Access Compliance Report

Public Rights-of-Way

(Curb Ramps)

Intersection ID: 18778	Main Street: E_INDEPENDENCE_BV	Cross Street: E_W_T_HARRIS_BV	Location: SW
ADA ID: 8E09F215D2E6	Ramp Type: Perpendicular	Initial Pass/Fail: Fail	Overall Compliance: No
Severity Score: 13.75			
Codes/Mitigation Info/Possible Solution		Field Measurements/Component Compliance

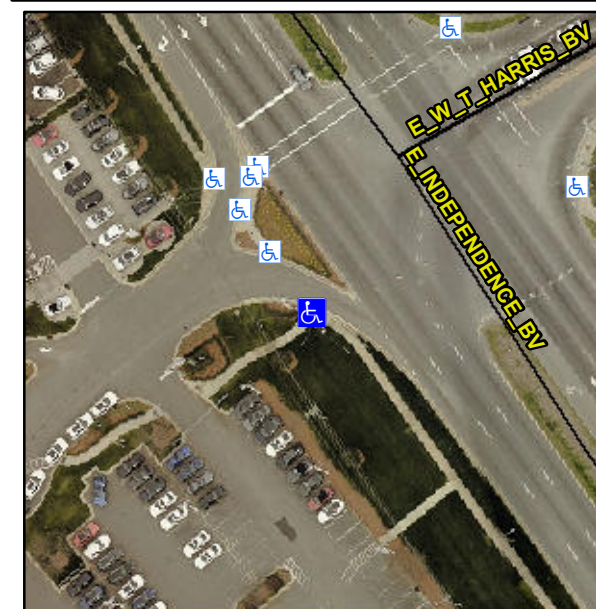
Not Found, R304.2.2, R304.5.3

Compliance	Description	Data	Compliance	Description	Data
N/A	Ramp Length (in)	57.0	No	Ramp Slope (%)	11.0
Yes	Ramp Width (in)	48.0	No	Ramp XSlope (%)	3.1
N/A	Flare Type LT	N/A	N/A	Flare Type RT	N/A
N/A	Flare Slope LT (%)	N/A	N/A	Flare Slope RT (%)	N/A
N/A	Flare Traversable LT?	N/A	N/A	Flare Traversable RT?	N/A
N/A	Landing Length (in)	N/A	N/A	DWS Provided?	N/A
N/A	Landing Width (in)	N/A	N/A	DWS Contrast?	N/A
N/A	Landing Slope (%)	N/A	N/A	DWS Length (in)	N/A
N/A	Landing X Slope (%)	N/A	N/A	DWS Full Width?	N/A
N/A	Landing Curb? (Y/N)	N/A	N/A	DWS Offset (in)	N/A
N/A	Shared Landing?	N/A			
N/A	Gutter Ponding?	N/A	N/A	Gutter Slope (%)	N/A
N/A	Gutter Lip Ht (in)	N/A	N/A	Gutter X Slope (%)	N/A
N/A	Painted X Walk1?	No	N/A	Painted X Walk2?	N/A
	X Walk 1 Direction	To NW		X Walk 2 Direction	N/A
N/A	X Walk 1 Width (in)	N/A	N/A	X Walk 2 Width (in)	N/A
	X Walk 1 Slope (%)	2.4		X Walk 2 Slope (%)	N/A
	X Walk 1 X Slope (%)	1.3		X Walk 2 X Slope (%)	N/A

Remove & Replace Entire Ramp.
